# TOWN OF HAYMARKET PLANNING COMMISSION

- a. #SP2017-003 Haymarket Town Center Redevelopment Final Site Plan

TO: Planning Commission  
FROM: Emily Lockhart, Town Planner  
DATE: September 28, 2017  
SUBJECT: Town Center Site Plan Update

Town Staff has received the Town Center Redevelopment Final Site Plans from the engineering consultant, Rinker Design Associates, PC (RDA). The final site plan is being presented for review at the October Planning Commission Meeting. Improvements to the site plan that received preliminary approval at the Town Council's August 1, 2016 meeting include;

**LANDSCAPE PLAN**  
**HAYMARKET TOWN CENTER  
REDEVELOPMENT**  
TOWN OF HAYMARKET, VIRGINIA

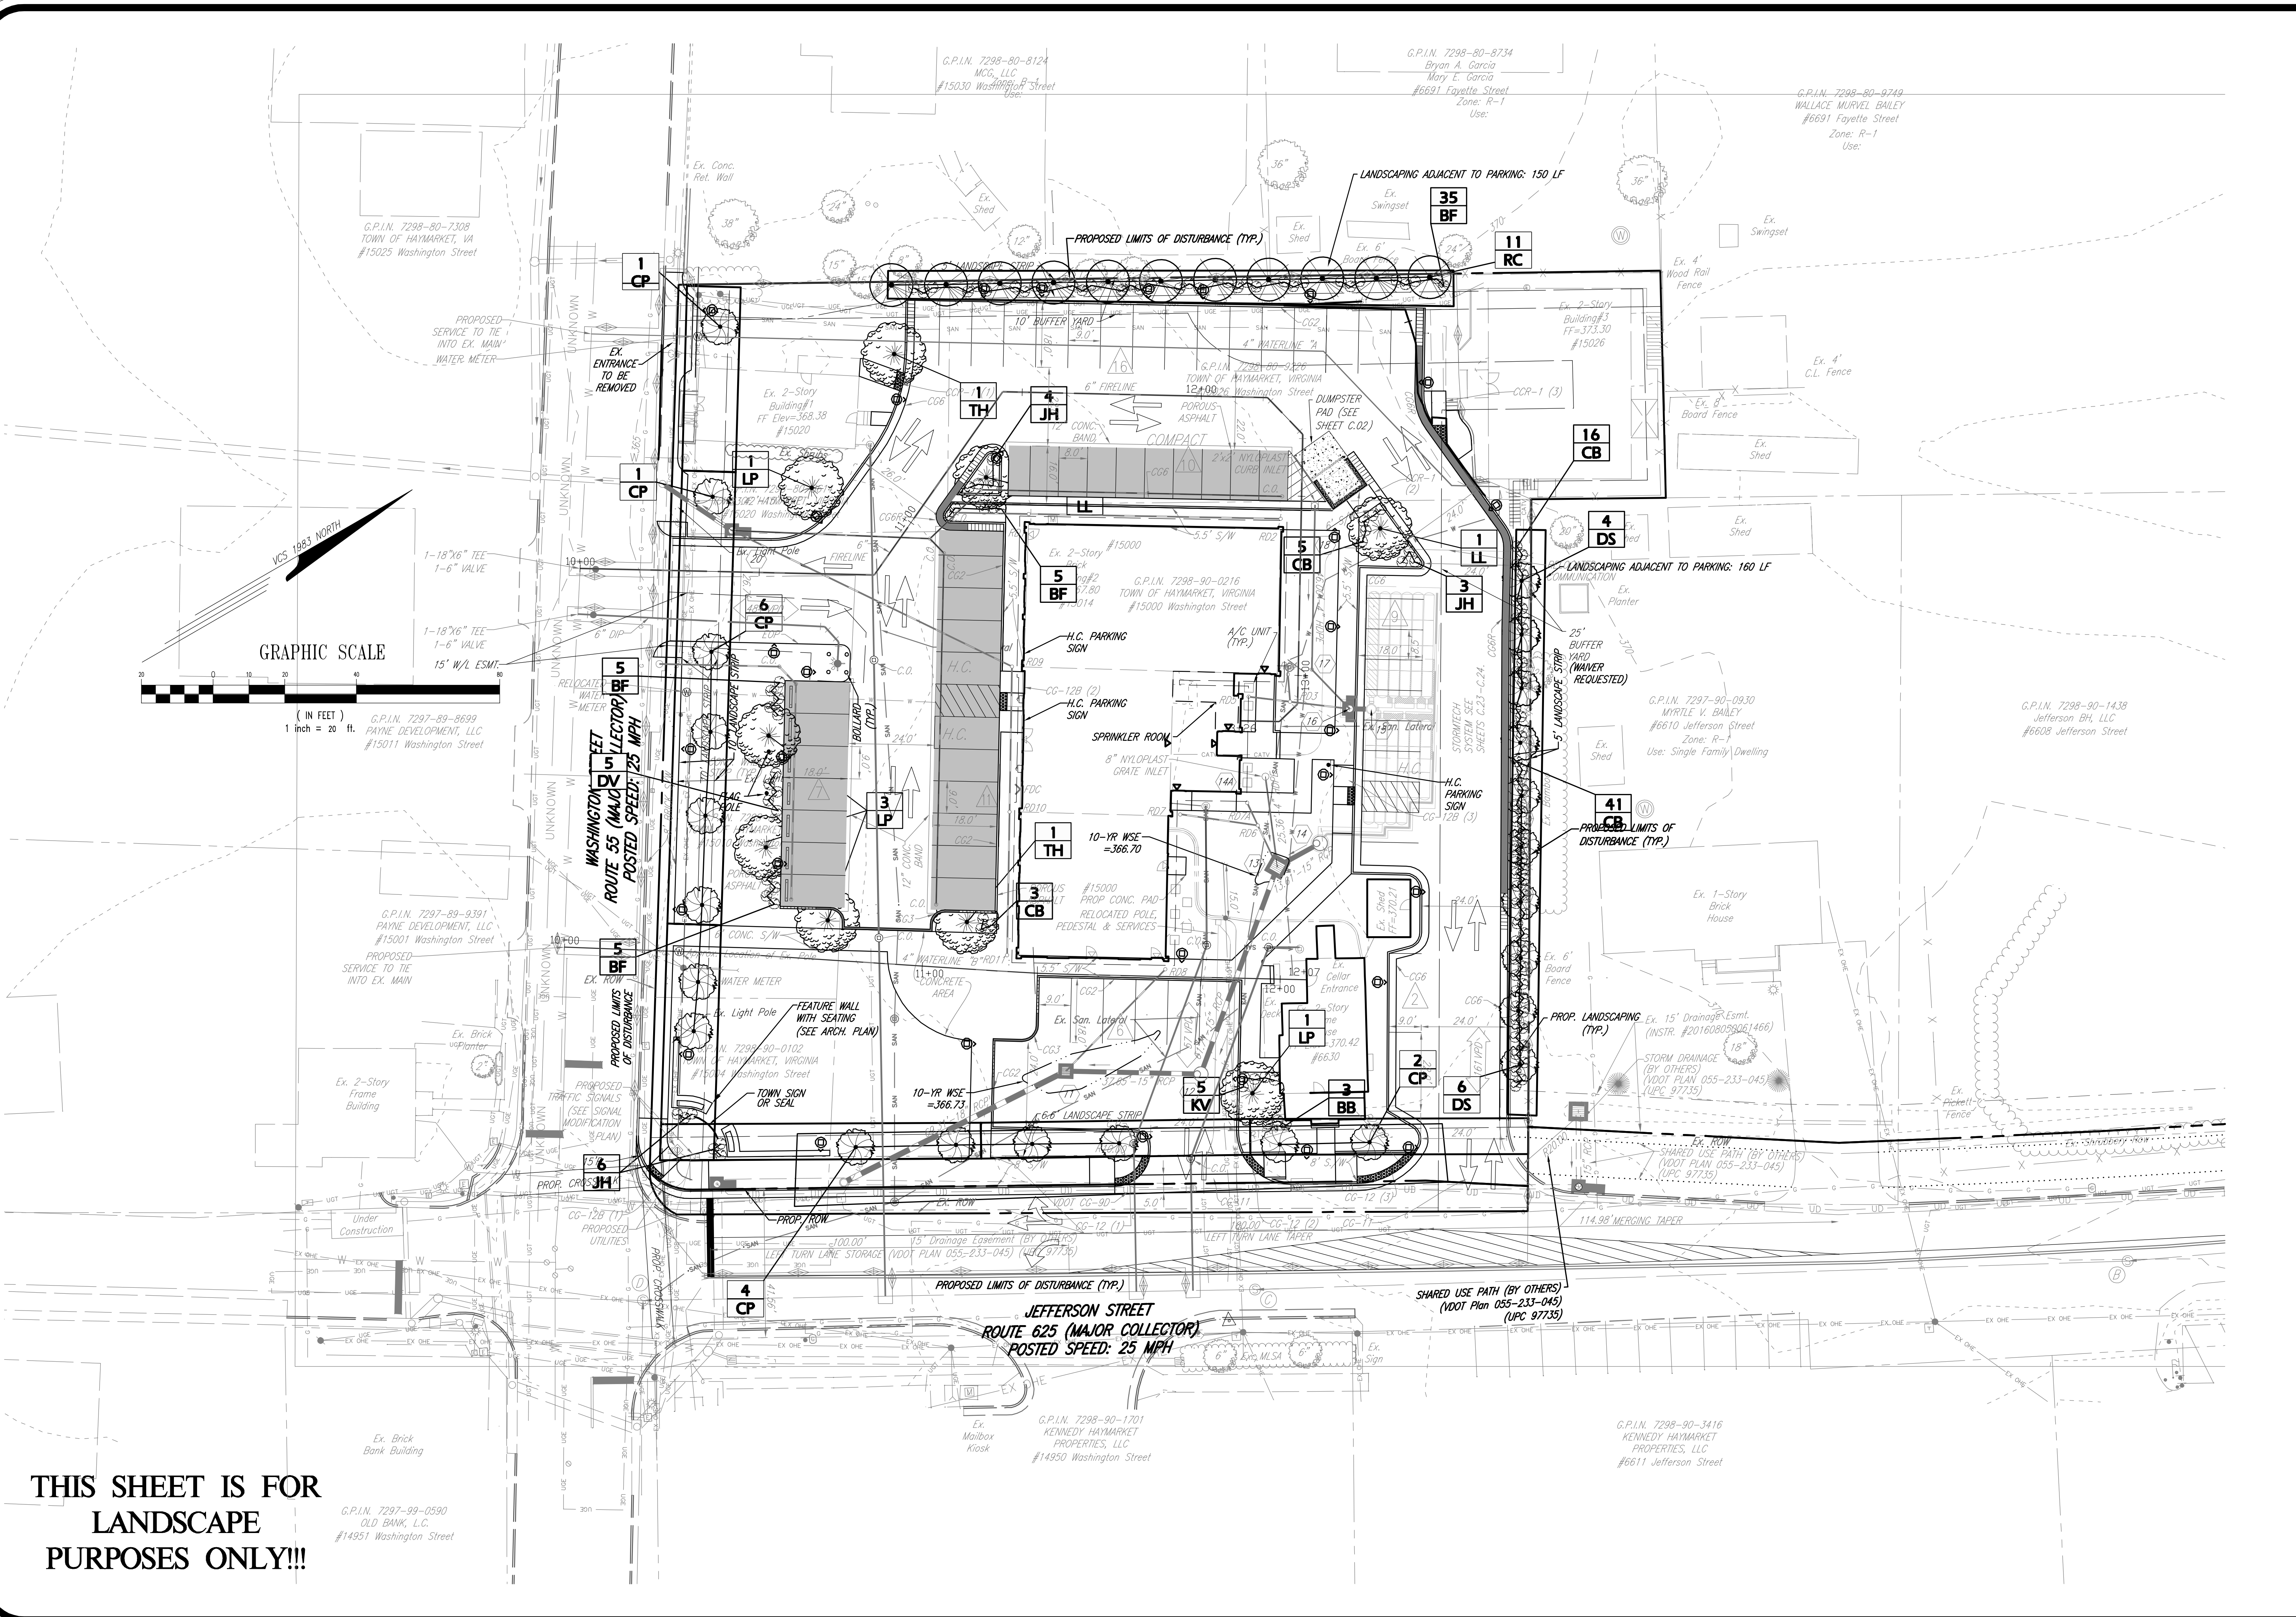
- London Planetrees planted along the Washington Street Frontage
  - Proposed Action: Plant 7 of the required 8 trees in 25' intervals. The existing building frontage, utility poles, guy wires and proposed feature wall provide obstructions only allowing 7 of the 8 trees to be planted at closer intervals.

- London Planetrees planted along the Jefferson Street Frontage
  - Proposed Action: Plant 6 of the required 8 trees in 25' intervals. The existing porch frontage (#6630), proposed town sign, proposed feature wall and shared use path provide obstructions only allowing 6 of the 8 trees to be planted at closer intervals.

Additionally, Staff recommends not using the London Planetree along the street landscaping buffers as the tree produces and sheds seed balls similar to the American Sycamore trees. Other canopy trees listed in Sec. 58-17.12 such as Red Maple may be a better alternative, staff suggestions the Planning Commission discuss this matter during their review. (The Required Plant Material List will be listed directly after this report for Planning Commission's use in review.)

- Recommendation: Amend the 8 tree requirement; the proposed action complies with Sec. 58-17.8(c). An additional tree has been added to the adjacent parking strip. The existing features create a barrier to planting 8 trees. The addition of 7 trees along Washington Street and the 1 adjacent tree will greatly increase the appeal of the property, the landscaping features and provide an attractive curb appeal.

- Recommendation: Amend the 8 tree requirement; the proposed action complies with Sec. 58-17.8(c). 6 trees planted along Jefferson St will be an enhancement to the property.
